Amendments to the Drawings:

Applic. No. 10/705,514
Response Dated July 9, 2007
Responsive to Office Action of March 8, 2007

Annotated Sheet

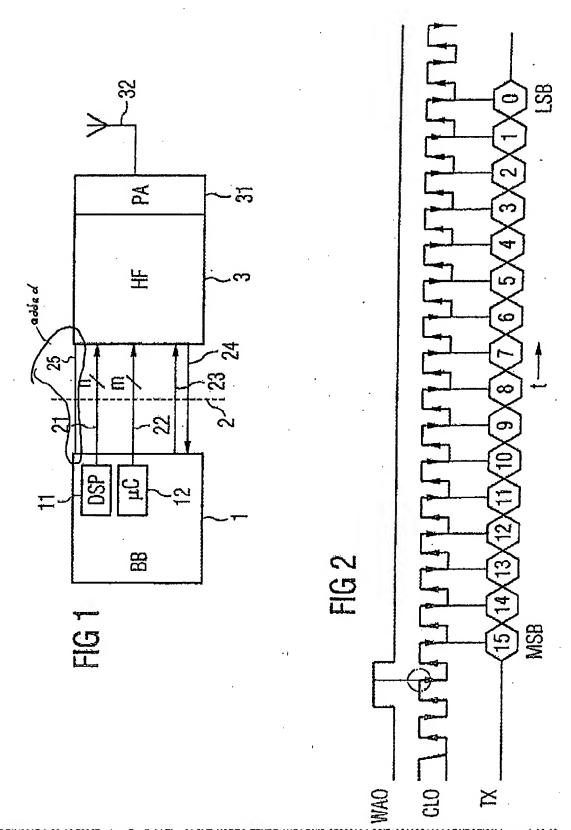
Fig. 1 has been amended to show a control line 25 extending from the baseband component to the radio-frequency component. A Replacement sheet and an annotated sheet showing the changes made are being included herewith. The amendment to the Fig. 1 is not believed to add new matter to the specification of the instant application.

In item 4 of the above-identified Office Action, the drawings were objected to as allegedly not showing every feature of the invention specified in the claims. More particularly, item 4 alleged that the drawings did not show "a data line for serial data transmission", "a bit clock line", "a word clock line", "a selection line" and "a control line for driving power amplifier". Applicants respectfully disagree.

Applicants have amended Fig. 1 to show a control line 25. As such, Applicants are appending hereto, a replacement sheet and an annotated sheet showing the change made to Fig. 1.

Additionally, the paragraph starting on page 17 of the instant application, line 9, has been amended herein to reflect the amendment to the drawings. The amendments to Fig. 1, as well as the amendments to page 17 of the specification, are supported by the specification of the instant application, as

In a further preferred embodiment of the present invention, an additional control line for driving a power amplifier for amplification of the radiofrequency signal is provided between the baseband component and the radio-frequency component.
